Re: New Office/ Ware House
541 Airport Dr. NW
Conceptual Traffic Circulation Layout for DRB Approval
Architect's Stamp 07-12-22 (K10-D023K)

DRAINAGE AND TRANSPORTATION INFORMATION SHEET (REV 6/2018)

**Re: NEW OFFICE/WAREHOUSE
541 Airport Drive NW
Traffic Circulation Layout
Architect's Stamp None (K10-D023)**

Subject-New Office/Warehouse- 541 Airport Drive NW
Traffic Circulation Layout Review

4 ACCESSIBLE PARKING
1/8"=1'-0"

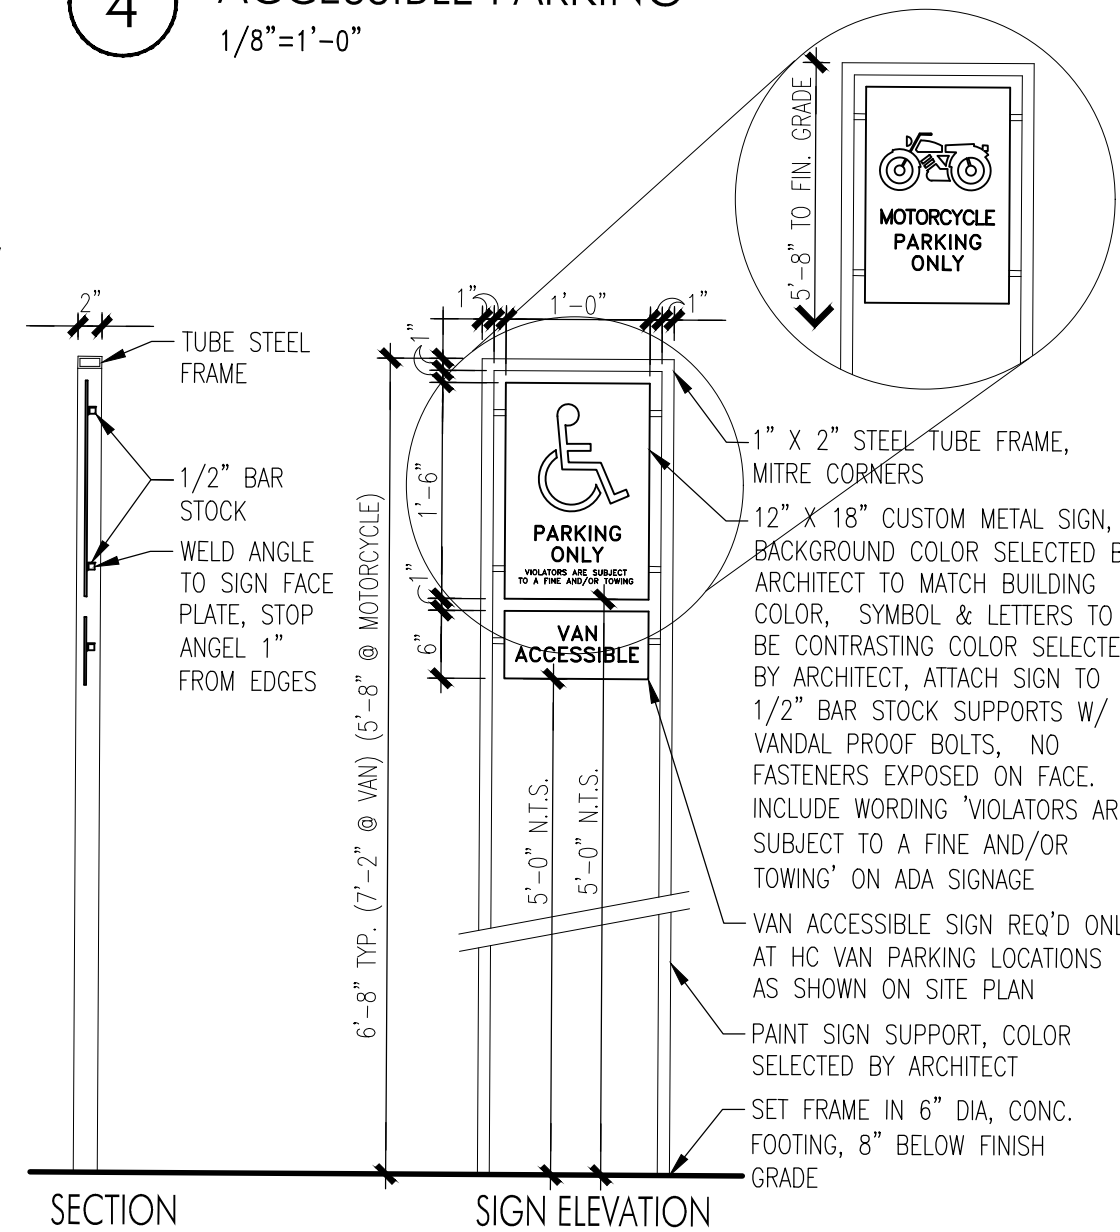
9. **Detail 4 (Accessible Parking):**
 - **The landing will need to be label 50:1 max in all directions.**

- **NO PARKING:** Detail for the text will need to be provided.

15. The ADA access aisles shall have the words **"NO PARKING"** in capital letters, each of which shall be at least one foot high and at least two inches wide, placed at the rear of the parking space so as to be close to where an adjacent vehicle's rear tire would be placed. (66-1-4.1.B NMSA 1978). **Provide details.**

9. Refer to revised details for HC parking.
10. Refer to revised drawings for clarifications doors, sidewalks etc.
11. Refer to revised drawings for easement and ROW clarifications.

15. Refer to revised ADA access aisle details.
16. Refer to revised plans for truncated domes at new curb ramps and the existing curb ramp at intersection.

3 PARKING SIGNS
3/4"=1'-0"

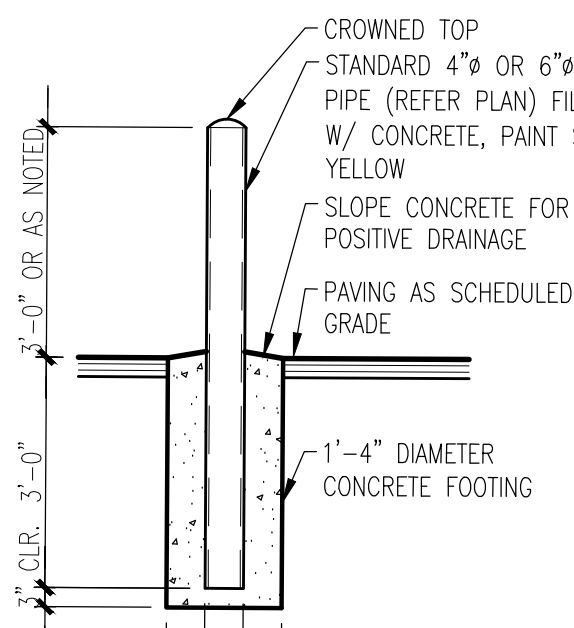
14. The ADA accessible parking sign must have the required language per 66-7-352.4C NMSA 1978 **"Violators Are Subject to a Fine and/or Towing."** Please call out detail and location of signs. The sign height is not correct. **Please review COA standards for correct signage height.**

12. Refer to revised plans.
13. Refer to revised motorcycle parking details for stall dimensions.
14. Refer to revised HC parking sign details for added notes.

DRAWING NAME
SITE DEVELOPMENT
PLAN
PHASE ONE

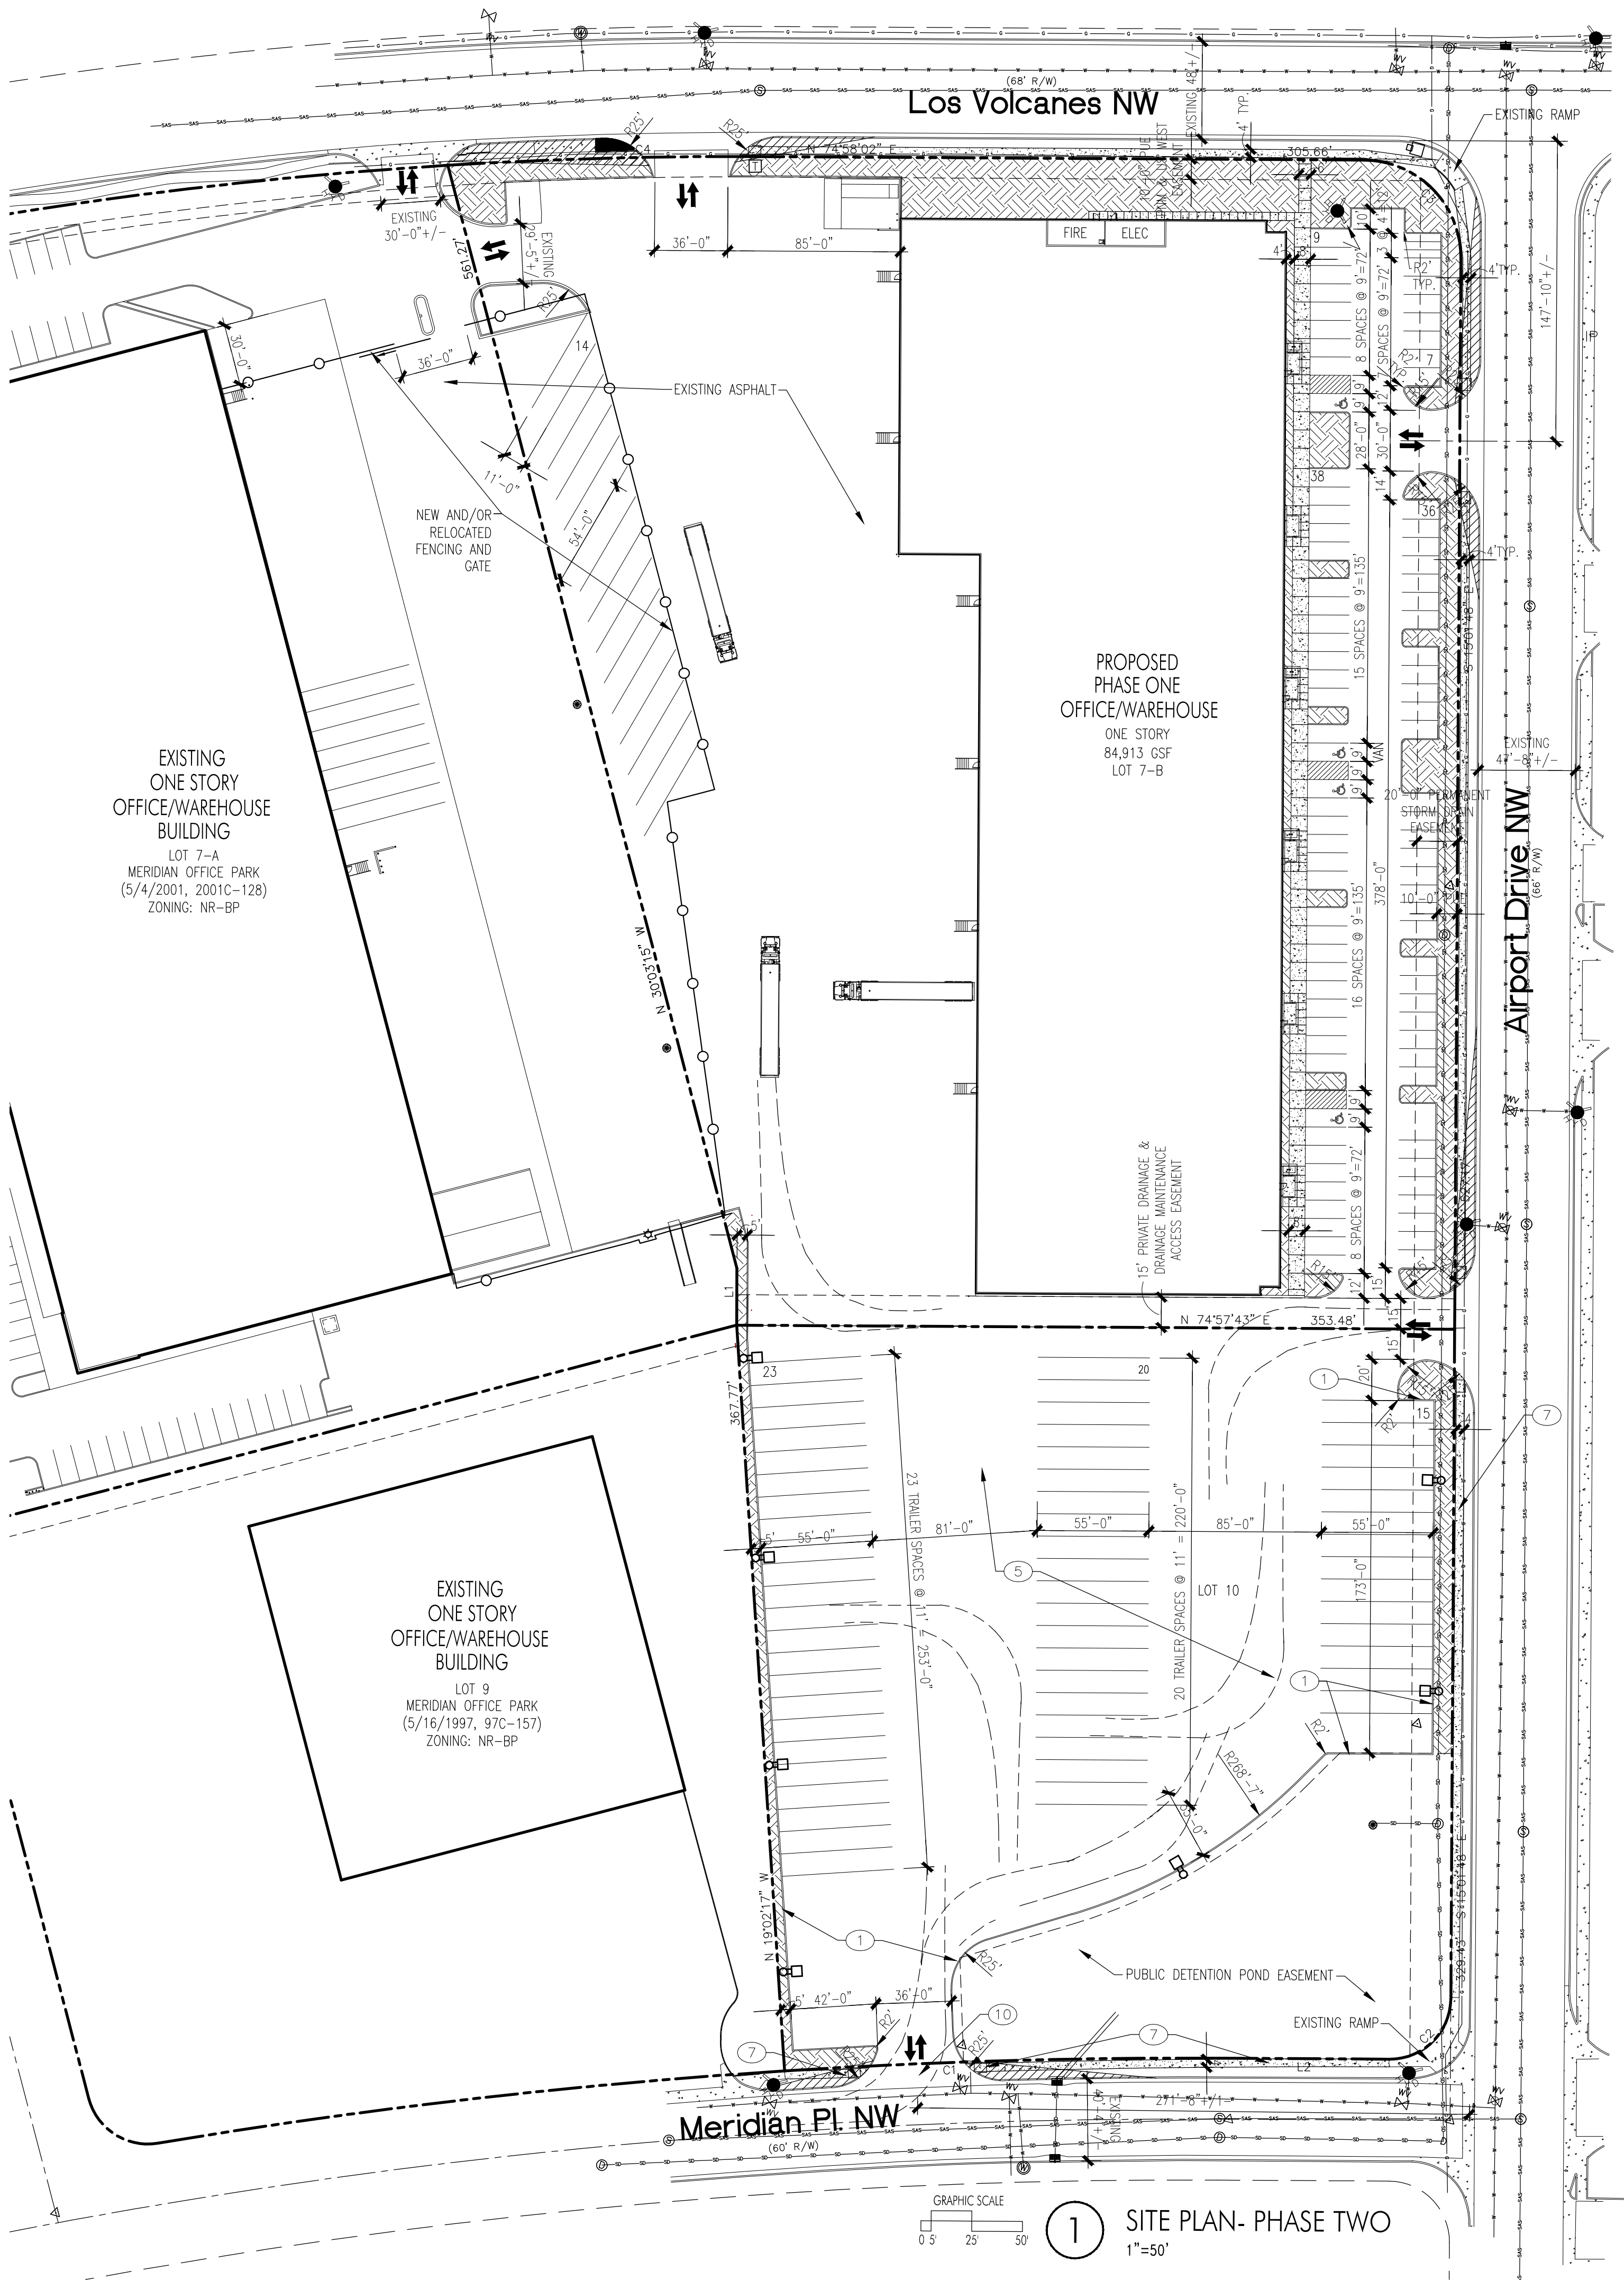
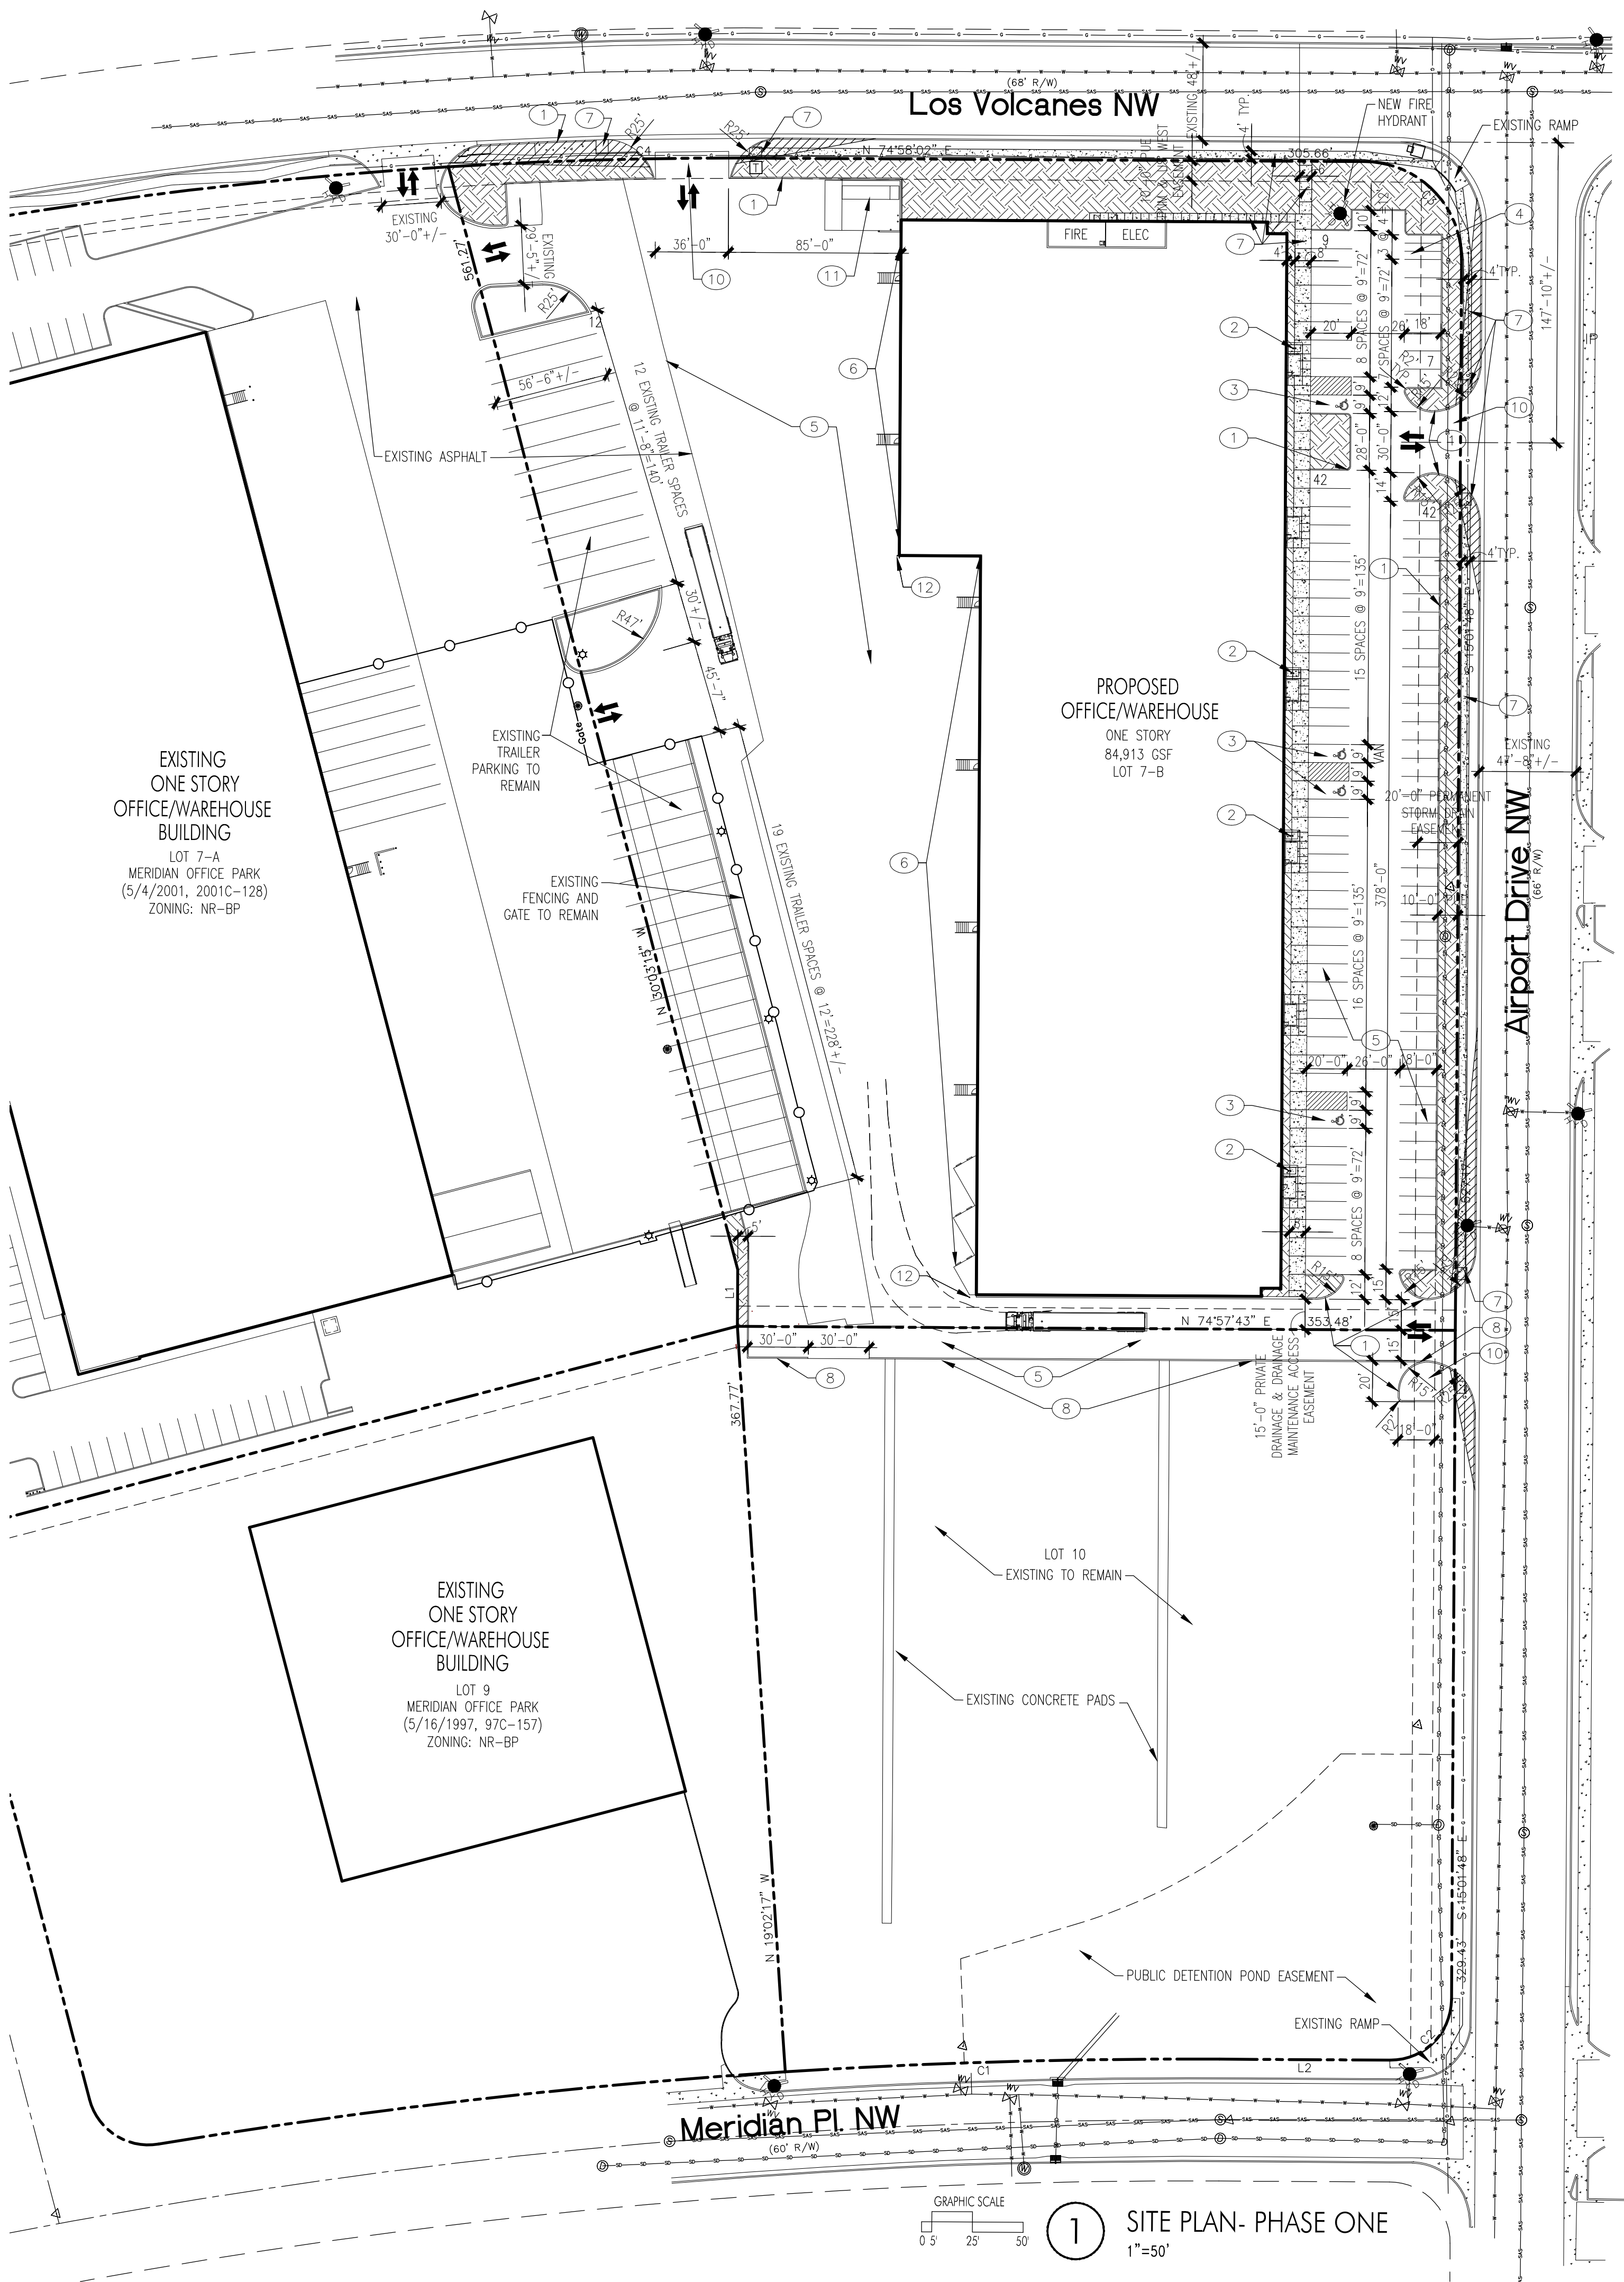
3. The traffic circulation layout must be stamped, signed, and dated by an engineer or architect licensed in the state of New Mexico.
4. **Proposed Driveway (Los Volcanes):** Provide entrance design or reference design per COA std dwg 2426.

5. **Airport Driveway:**
 - **First proposed drive entrance location:** What is the distance from Los Volcanes? Verify you meet the required distance from a Collector on Airport.

- **Second proposed driveway:** How will you provide a 6 ft valley gutter across the 30 ft driveway when you are only providing temp. extruded curb and status of ramp on the southside of entrance.

6. **Keyed Note 1:** Please reference detail and sheet number.
7. **Keyed Note 7:**
 - Please provide entrance ramp detail since a detail has not been provided.

- Sidewalk detail will be needed and reference COA std dwg 2430 (public sidewalk) on both Los Volcanes and Airport Drive (when applicable).
8. **Keyed Note 8:** Need to provide detail.

10. Please identify all **proposed buildings, doors, structures, sidewalks**, curbs, drive pads, wall and anything that influences the parking and circulation on the site.
11. Identify all existing access easements and rights of way width dimensions.
12. Identify the right of way width, medians, curb cuts, and street widths on Los Volcanes and Airport Drive.
13. **The minimum parking stall dimensions are:**

16. All ADA curb ramps within public ROW must be updated to current standards and have truncated domes installed. Please verify corner of Los Volcanes/Airport ramp complies with these requirements stated.

26. Corner of building will need bollards (details need and painted traffic yellow) so delivery truck will be aware and avoid any type of conflict.
 27. Provide a copy of refuse approval.

30. Please provide a sight distance exhibit
 31. **Intersection Sight Distance:** A clear sight line will be needed on Airport and Los Volcanes intersection for turning movements for Airport Drive.

32. Show the clear sight triangle and add the following note to the plan: "Landscaping and signage will not interfere with clear sight requirements. Therefore, signs, walls, trees, and shrubbery between 3 and 8 feet tall (as measured from the gutter pan) will not be acceptable in the clear sight triangle.

3. Revised plans have architect stamp, signed and dated.
4. Refer to revised plans for noted standard drawings at driveways.
5. Refer to revised plans for distance to drive and clarification on extent of the temp. extruded curb. Both Airport and Los Volcanes are collector streets.

6. Refer to revised plans for detail reference.
7. Refer to revised plans for std. dwg notes for ramps and sidewalks.
8. Refer to revised plans for temp. extruded curb detail.

23. Refer to plans for clarification. We have 8' wide sidewalks along the entire length of the building. We have hatched the conc. sidewalks to help clarify.

24. Refer to revised plans.
25. All parking areas have either conc. curbs or conc. parking bumpers.
26. Refer to revised plans for added bollards at corner.

27. Solid Waste approved plan is attached.
28. Approved Fire One plan is attached.
29. Refer to revised plans for paving design note.
30. Refer to revised plans for clear site triangles.

31. Refer to revised plans for site distances. See the legend for hatching.
32. Same as 30 above.
33. Refer to revised plans for added City Standard Drawing numbers.

Please refer to the revised SDP-1 and SDP-2 along with supporting documents. Let us know if you need any further clarification.
